## Addendum No. 4

Date: 05-20-2024

Project Name: NECSD – New CTE Building

CSArch Project No. 108-2303

1 ENLARGED FLOOR PLAN - AUTO BODY SHOP  
A616 1/4" = 1'-0"

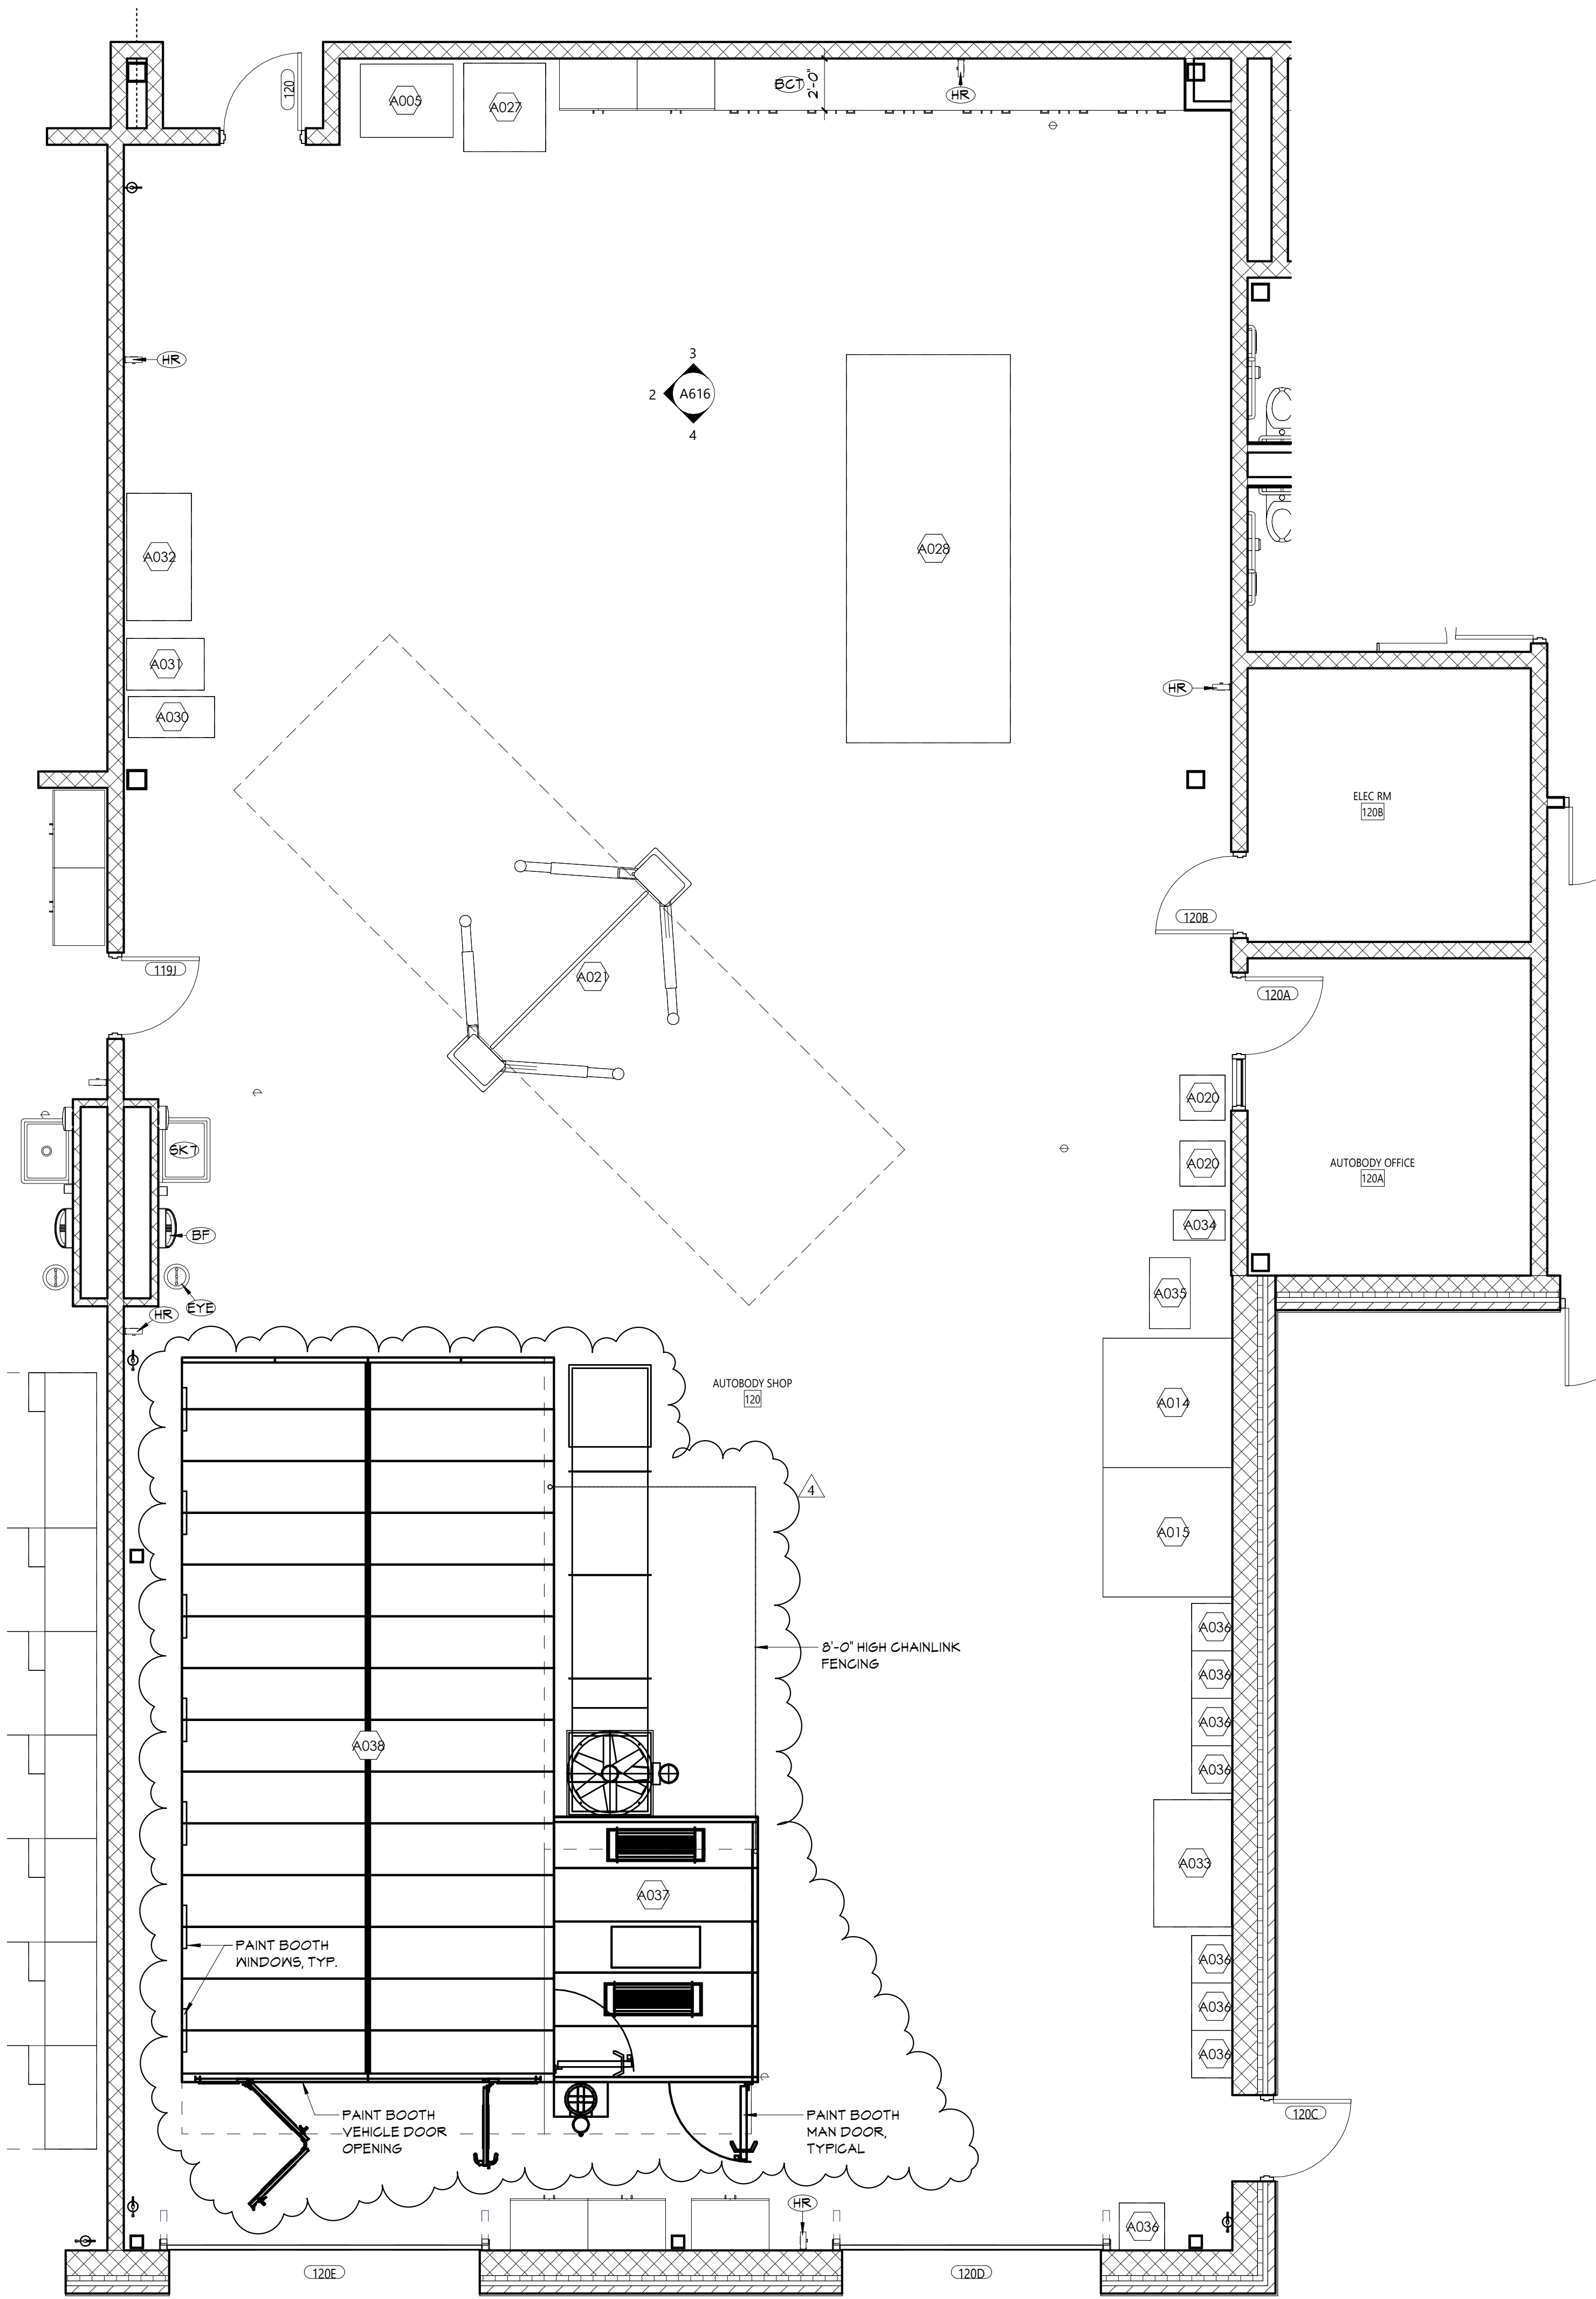
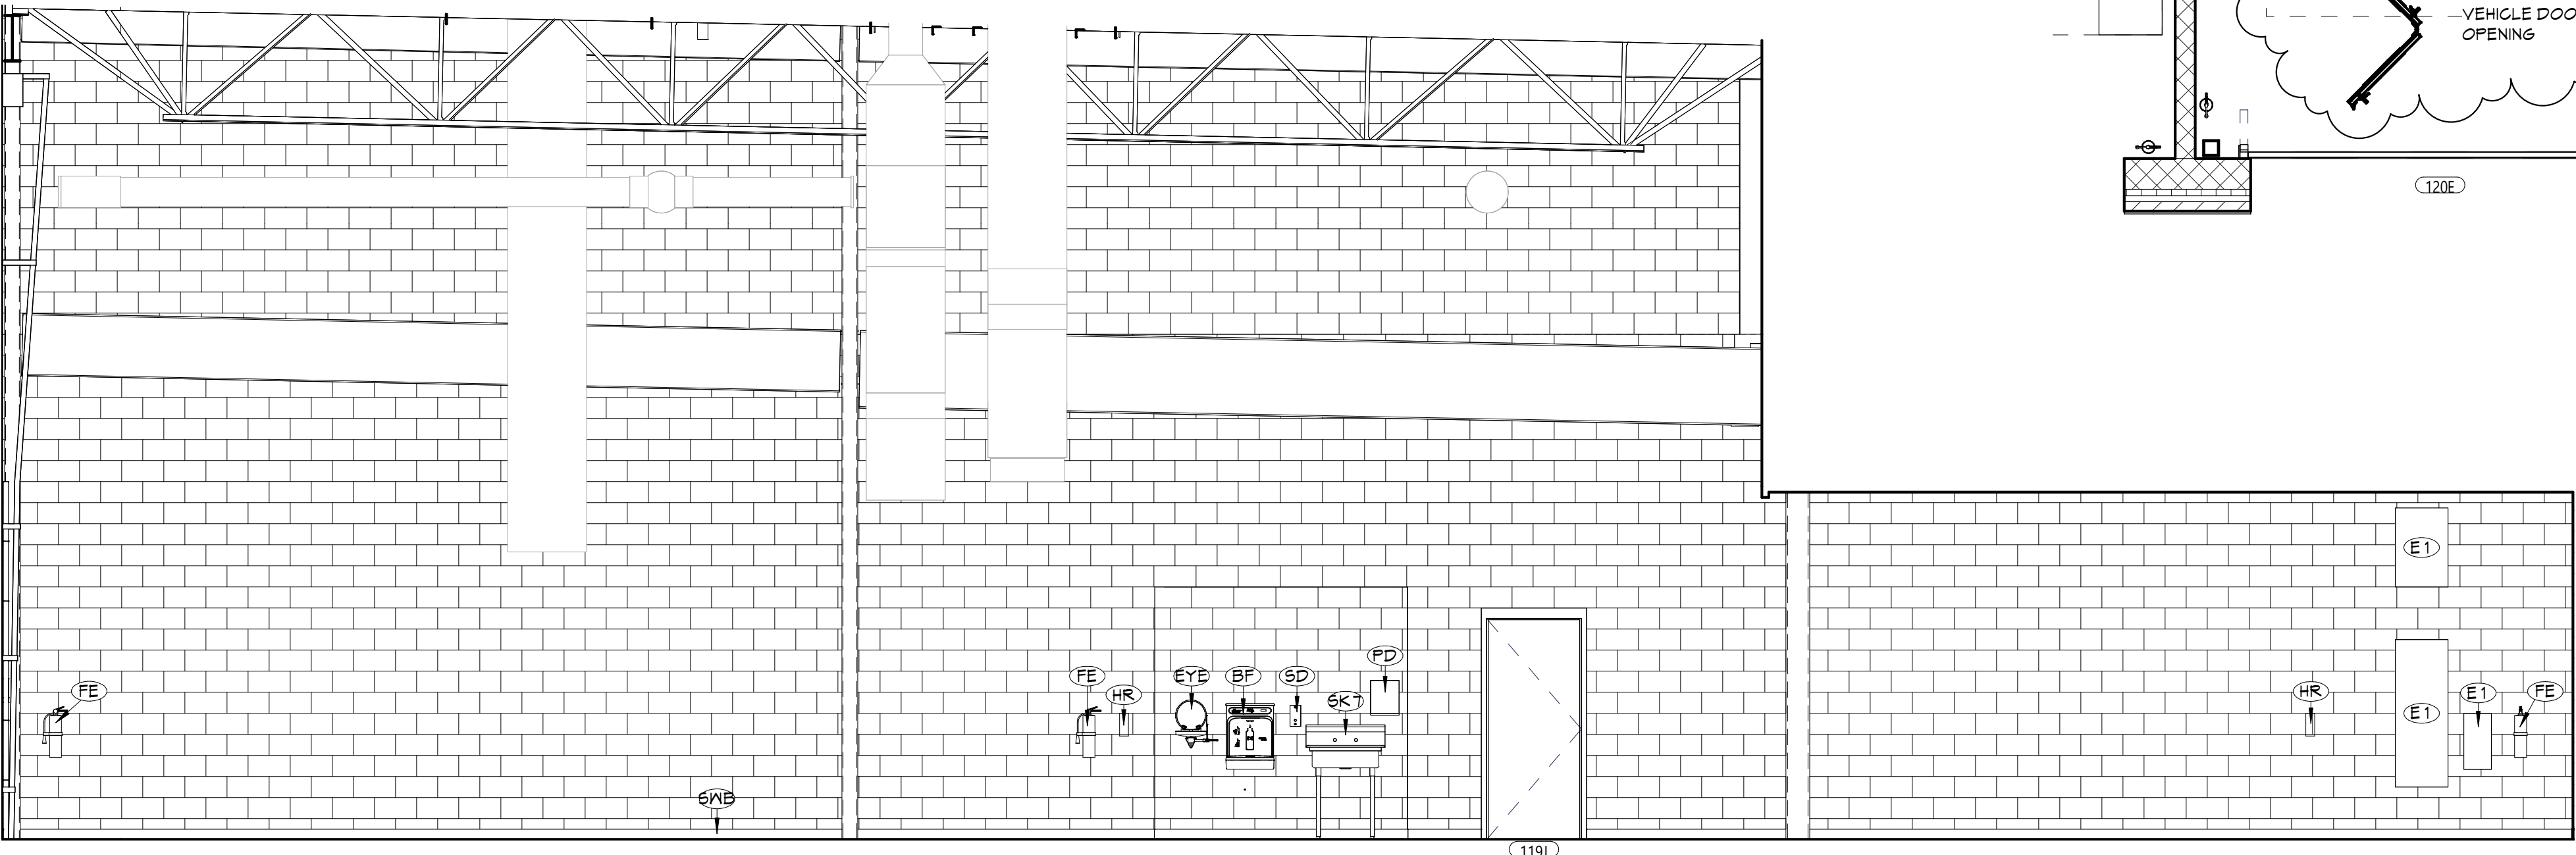
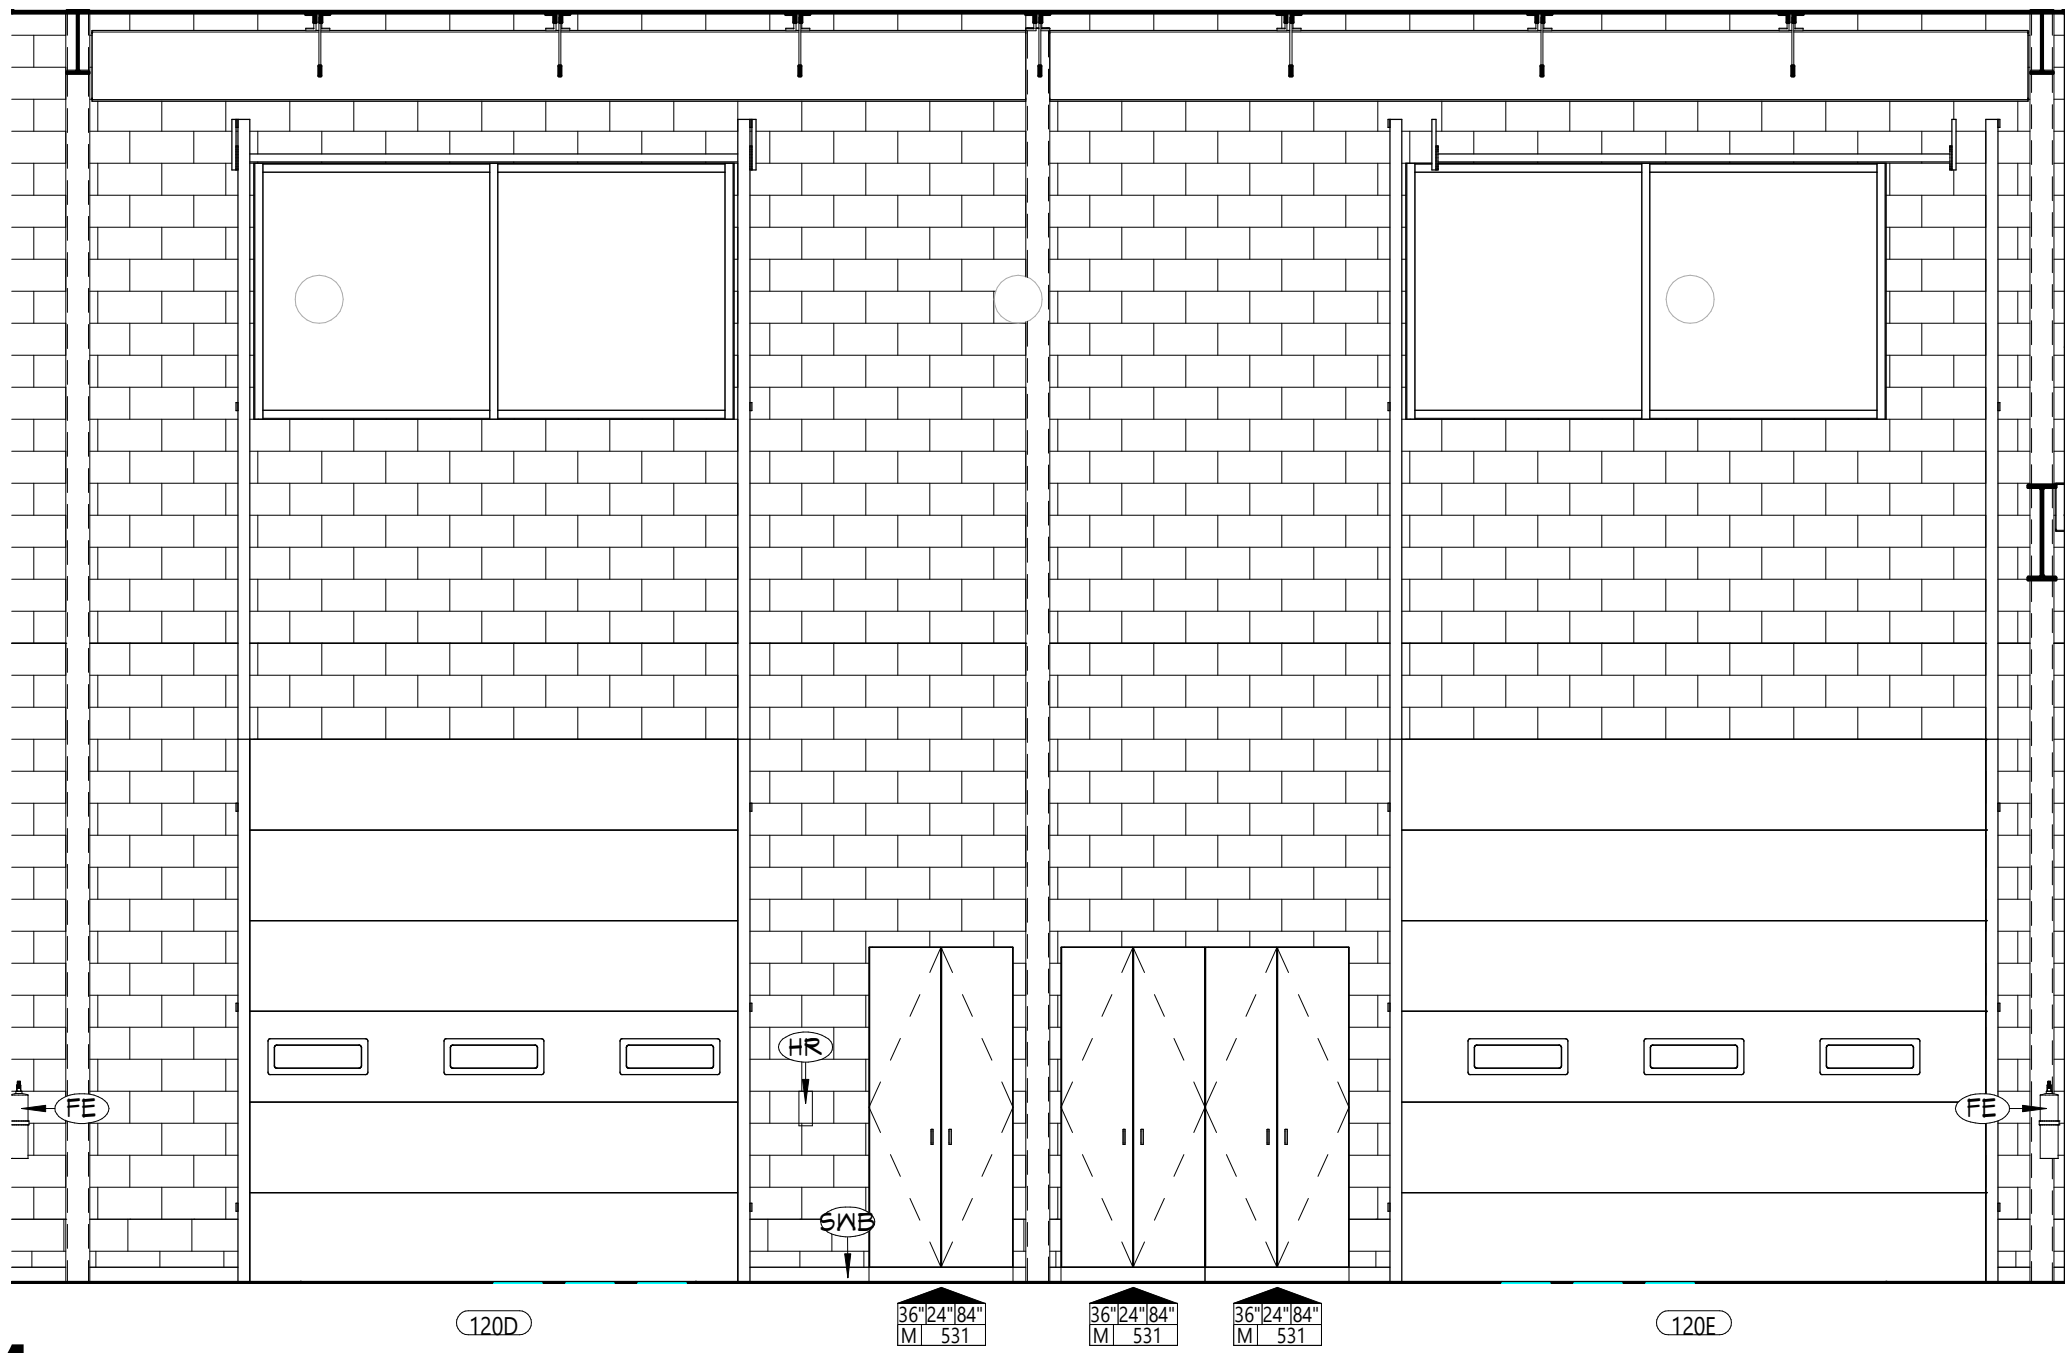
124	M	Refrigerant Lines	On the mechanical drawings there are now refrigerant lines sizes. Please provide sizes of the refrigerant lines or more detail.	5/16/2024	Pike Construction Services, Inc.	Response Pending, Open RFI				
125	M	Condensing Units	On M901 there seems to be missing information on air cooled condensing units CU-F-6, and CU-J-1 and what indoor units they serve. The VRF systems table is incomplete. Can you provide that information and complete the served indoor units table?	5/16/2024	Pike Construction Services, Inc.	Revised as part of addendum #4.	Yes	M901		Add #4
126	A/M	Paint Booth	Please clarify if the paint booth is owner provided. Can you provide more information on the paint booth as far as model #, accessories, and scope responsibilities? Can you provide contact info for the paint booth representative?	5/16/2024	Pike Construction Services, Inc.	As per the equipment schedule on drawing A616, the paint booth is contractor provided. Revised equipment plan provided as part of addendum #4.  Refer to specification section 233500 for paint booth requirements.	Yes	A616		Add #4
